Staff Report to the Planning Commission

Application Number: **04-0423**

Project Description: Proposal to divide a 12,950 sq. ft. lot into two lots of 6,000 and 6,950 sq. ft., construct one single-family dwelling, and remodel and demolish a part of an existing dwelling at 3561 Thurber Lane. Requires a Minor Land Division and a Residential Development Permit for modifications to an existing significantly non-conforming structure.

URBAN DESIGNER'S COMMENTS

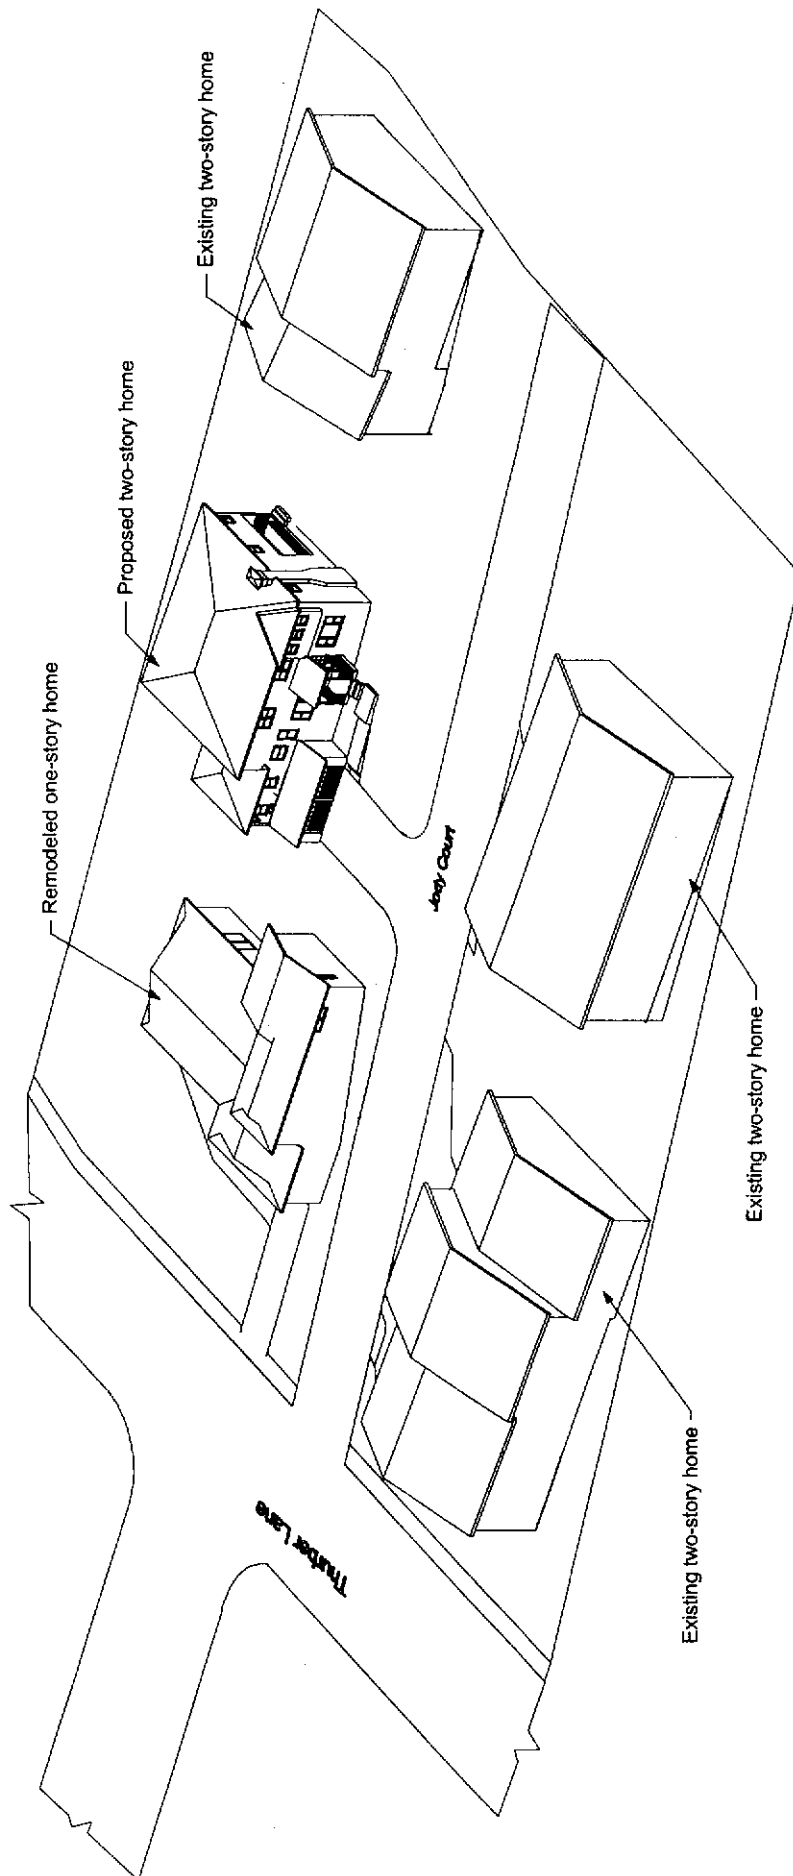
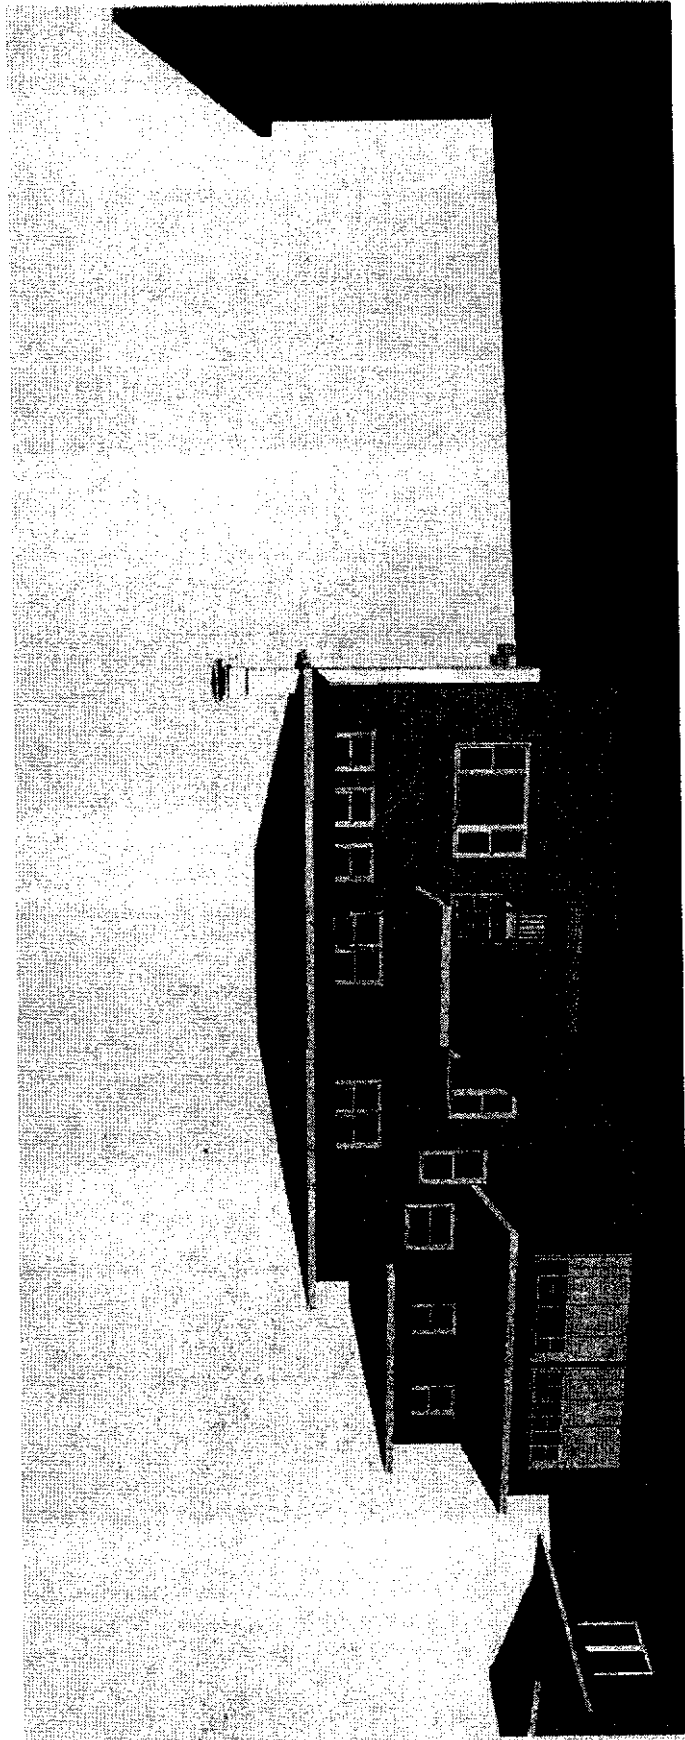
*The design should have horizontal **siding** instead **of** stucco. The **stucco** increases the look **of** massiveness and the haphazard window placement.*

*Columns **on** porches should be bigger and have **both** caps and bases (i.e. 1x trim).*

- *Neither **the** civil plan nor the architect's site plan should show **ANY** new landscaping*
- *The **new driveway** at the south side **of** the **front** lot does **not** match the landscape plan **or** civil site plan **in** width.*

*The landscape architect should label the species **of** Magnolias to remain (**these** are **not** shown **on** the civil plan).*
